SRC 2017-195
signal activation ($\phi 3$ and $\phi 7$)
16 JUNE 2018
People present:
Kristen Nugent
Cynthia Hui
Michael Chu
Wei Zhang

MISSION BAY PROJECT - SAN FRANCISCO, CA		OWENS STREET PUBLIC IMPROVEMENTS		SIXTEENTH ST. & OWENS ST. SIGNAL PLAN	
		BAR IS ONE INCH ON ORIGINAL DRAWING IF NOT ONE INCH ON THIS SHEET, ADJUST SCALES ACCORDINGLY		SEE DWG. NO. RGS DWG. NO. DWG.	
GHD INC. 1000 California Street, Suite 200 San Francisco, California 94111 USA Tel: 415 774 2000 Fax: 415 774 2000 E: info@ghd.com				SANDISI 1000 California Street, Suite 200 San Francisco, California 94111 USA Tel: 415 774 2000 Fax: 415 774 2000 E: info@sandisi.com	
ORDER: FOCL-01, LLC PROJECT: LANDMARK				MISSION BAY DEVELOPMENT GROUP	
418 CHINA BAS & STREET BAY FRANCISCO, CA 94108		1/3/14 3/28/13 5/14/13 DEC		INSTRUCTIONAL BULLETIN #4 - POLE CHANGES INSTRUCTIONAL BULLETIN #2 ISSUED FOR PERMIT DPL	
REVISIONS		REVISIONS		REVISIONS

MISSION BAY PROJECT - SAN FRANCISCO, CA
OWENS STREET
PUBLIC IMPROVEMENTS
SIXTEENTH ST. & OWENS ST.
CONDUIT & EQUIPMENT SCHEDULES

03340.12.046
80 of 104
T1.3

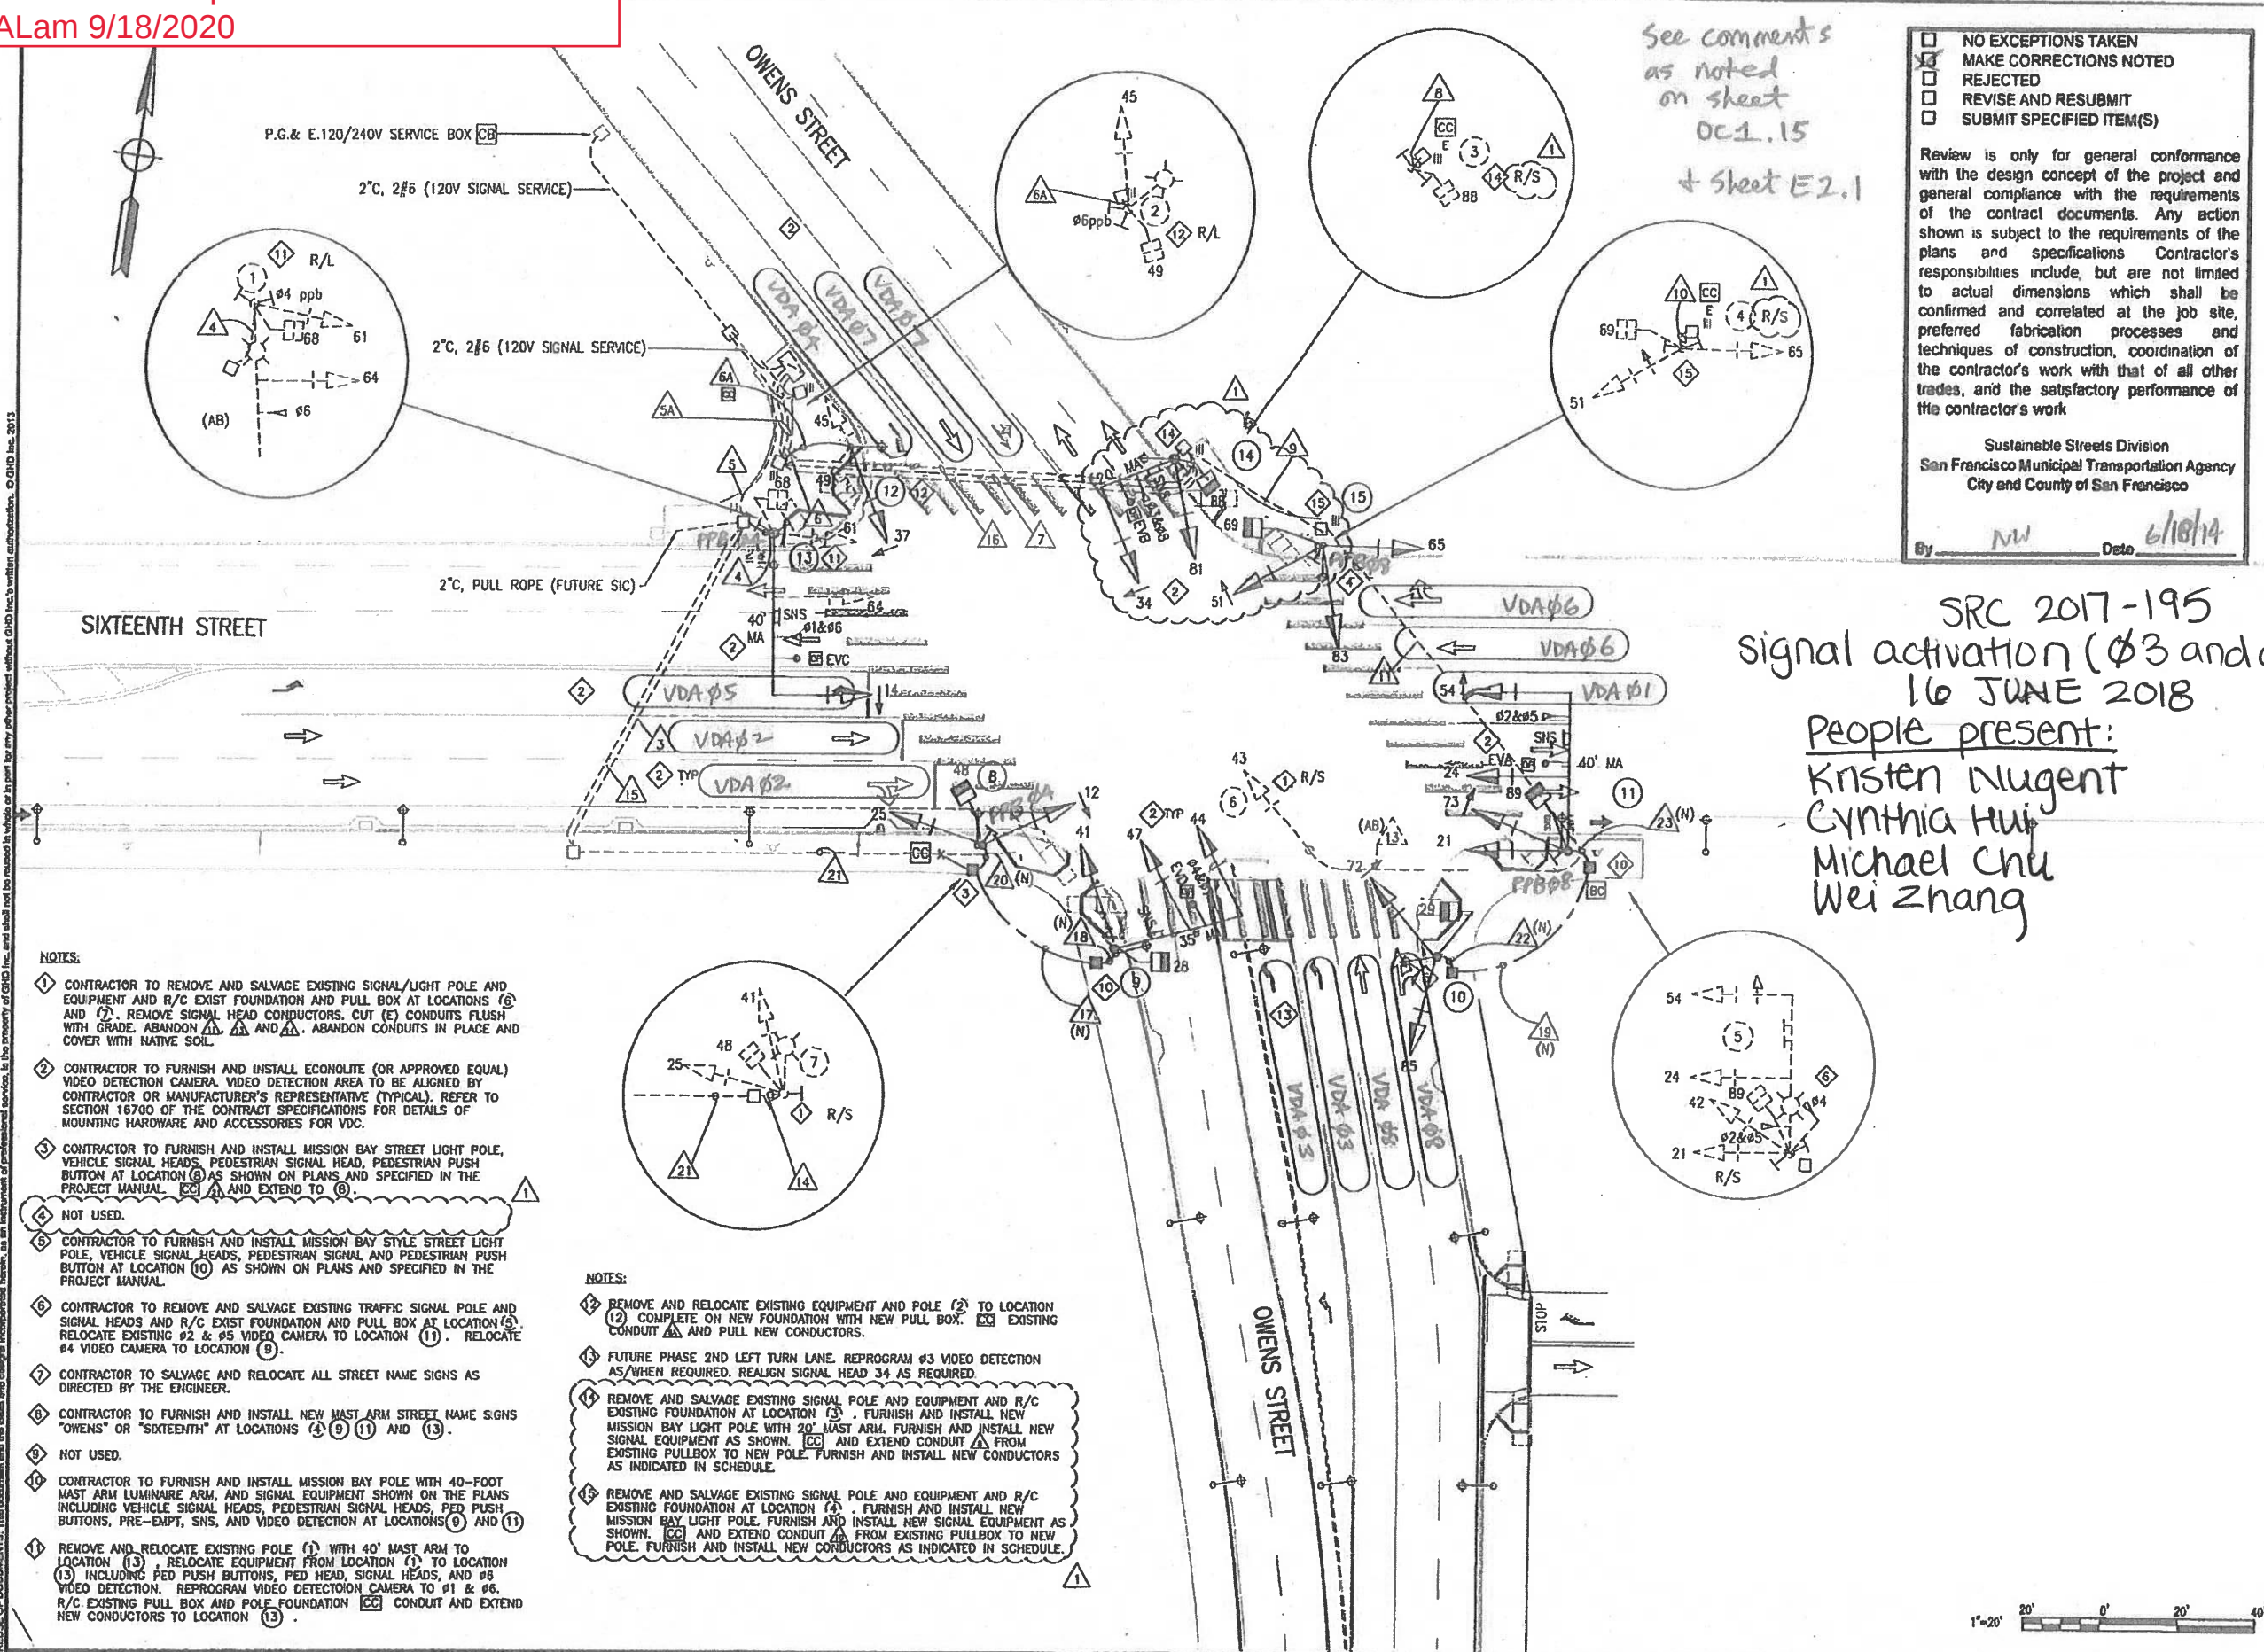
☐ NO EXCEPTIONS TAKEN
☒ MAKE CORRECTIONS NOTED
☐ REJECTED
☐ REVISE AND RESUBMIT
☐ SUBMIT SPECIFIED ITEM(S)
